Subject: MHI's Revised Response to US-APWR DCD RAI No. 687-5394 Revision 2 (SRP 15.0.0.7 and 8.2.3)

MHI's Revised Response to US-APWR DCD RAI No. 687-5394
Revision 2 (SRP 15.0.0.7 and 8.2.3)

RAI NO.: NO. 687-5394 REVISION 2
SRP SECTION: 15 – INTRODUCTION – TRANSIENT AND ACCIDENT ANALYSES)
APPLICATION SECTION: 15.0.0.7 and 8.2.3
DATE OF RAI ISSUE: 1/27/2011

QUESTION NO.: 15.0.0-24

Figure-1 Generator Circuit Interlock Diagram

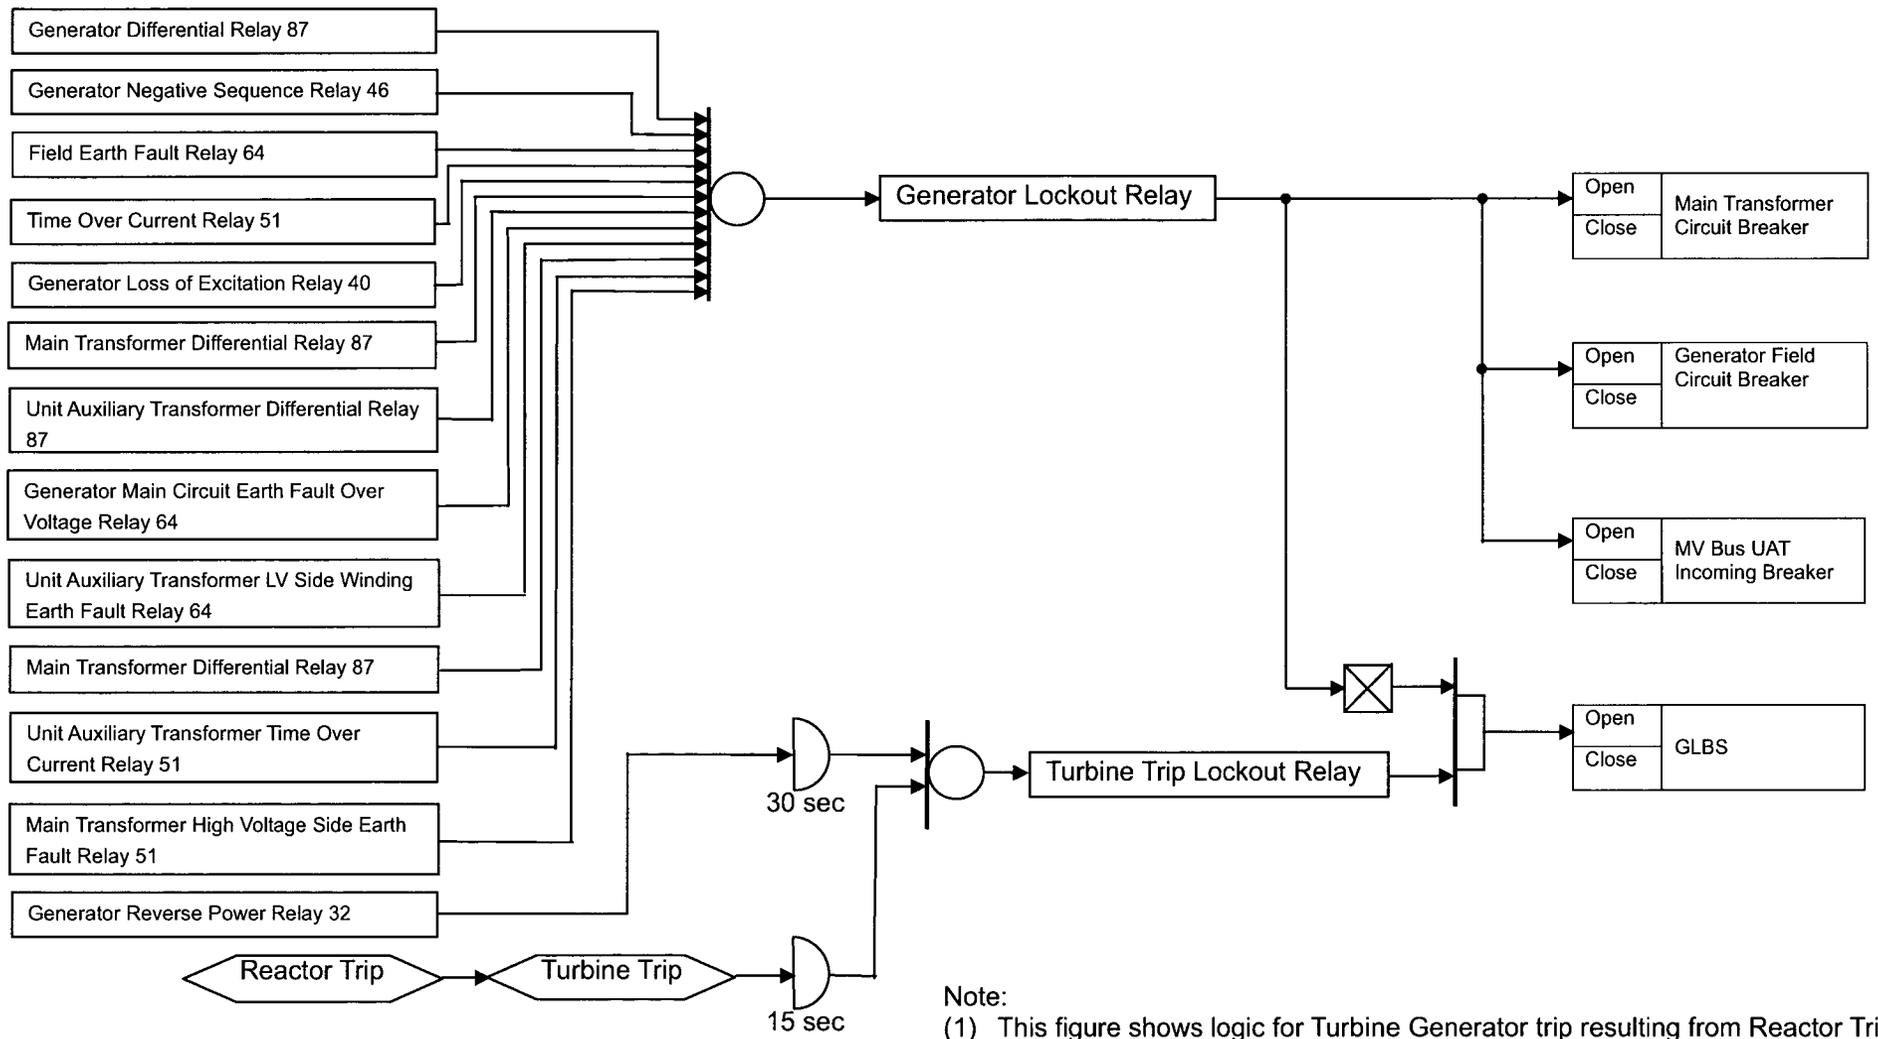
The NRC staff notes that there is an inconsistency between Chapter 8 and Chapter 15 with respect to the basis for the 3 second time delay between a reactor trip and the loss of offsite power (LOOP). Per DCD Section 15.0.0.7, the safety analyses assume that a LOOP occurs a minimum of 3 seconds after a reactor/turbine trip to account for the time it would take for grid instability, caused by the turbine-generator trip, to propagate through the grid to the plant offsite power source. However, Section 8.2.3 states that in the event of a LOOP concurrent with reactor/turbine trip, the main generator remains connected to the grid powering reactor coolant pumps (RCPs) thru the UATs and that the large inertia of the turbine-generator will maintain voltage and frequency for more than 3 seconds.

- a) If the statement in Section 8.2.3 provides the relied-upon basis, describe in detail how the large inertia of the turbine generator would maintain adequate voltage and frequency to the RCPs for an additional 3 seconds, assuming that a LOOP occurs concurrently with a reactor/turbine trip. The staff is concerned that during this event the main generator would attempt to power the grid and may not be able to support adequate voltage and frequency for the RCPs for 3 seconds to satisfy the Chapter 15 safety analysis assumptions. Therefore, the applicant needs to show that adequate voltage and frequency will be maintained during this scenario before the generator is separated from the grid.

- b) If the statement in Section 15.0.0.7 of the DCD provides the relied-upon basis, provide an analysis that demonstrates that a LOOP occurs a minimum of 3 seconds after a reactor/turbine trip to support this assumption. As part of this analysis, provide the basis for the conclusion that this is a bounding situation given the site-specific nature of such analysis.

The second case, where the LOOP is a secondary event during the transient, pertains to DCD Section 15.0.0.7. The RCPs may receive electrical power from either the turbine generator or the offsite power grid. Certain Chapter 15 events result in a reactor trip. A reactor trip causes a turbine generator trip. It is assumed that this turbine generator trip could cause a grid disturbance which could ultimately result in a LOOP. This scenario would result in a loss of electrical power to the RCPs and a loss of flow transient would begin in addition to the initiating event. When applying this scenario to the Chapter 15 events, the safety analyses assume that electrical power to the RCPs can be maintained to the RCPs for at least 3 seconds following the turbine generator trip. The RCPs are assumed to continue to run during this 3 second period and provide normal RCS flow. The description in Subsection 15.0.0.7 was intended to explain this assumption and provide the basis. However, the information in Subsection 15.0.0.7 was not intended to describe the detailed design of the electrical distribution system. That information is more appropriately described in DCD Chapter 8. Therefore, Subsection 15.0.0.7 will be revised to describe the 3 second assumption used in the safety analyses and to explicitly refer to Chapter 8 for the relied-upon basis for the 3 second assumption. The changes to DCD Chapters 8 and 15 are shown in the "Impact on DCD" section below. "Figure-1 Generator Circuit Interlock Diagram" is attached below to supplement the information about the impact on DCD Chapter 8.

When a reactor/turbine trip occurs, the turbine trip signal is actuated to trip the main generator and open the GLBS. Prior to the GLBS opening, the generator will motor at a synchronous speed governed by the grid frequency. Since the generator remains connected to the UATs, the RCPs are powered by the generator. Therefore, power to the

RCPs will be maintained as long as the generator is motoring on the offsite power grid. The time delay between the reactor/turbine trip and the main generator trip/GLBS opening is set as 15 seconds. The reverse power relay is provided to protect the generator from motoring. It trips the generator and opens the GLBS after a 30 second delay from its actuation. The time delay is set within the permissible time for anti-motoring protection (maximum about one minute). The 30 second anti-motoring protection time delay serves as a backup to the 15 second reactor/turbine trip time delay in opening the GLBS. However, neither of these timers are credited in the Chapter 15 analyses. After the generator trips and the GLBS opens, the RCPs will be powered directly by offsite power through the UATs. As a result of this design, the RCPs will be continuously powered following a reactor/turbine trip for as long as offsite power is maintained. Since the stability of the offsite power is expected to be maintained for at least 3 seconds, this ensures the power supply to the RCPs assumed in the Chapter 15 analyses, regardless of the time delay between the reactor/turbine trip and the main generator trip/GLBS opening or the time delay for reverse power relay. The interface requirement for offsite power is maintaining a transmission system operating voltage of $\pm 10\%$ and a frequency of $\pm 5\%$ at the interface point between the transmission and offsite power system as defined in DCD Section 8.1.2.2. The COL Applicant is to perform the grid stability analysis to confirm this interface requirement.
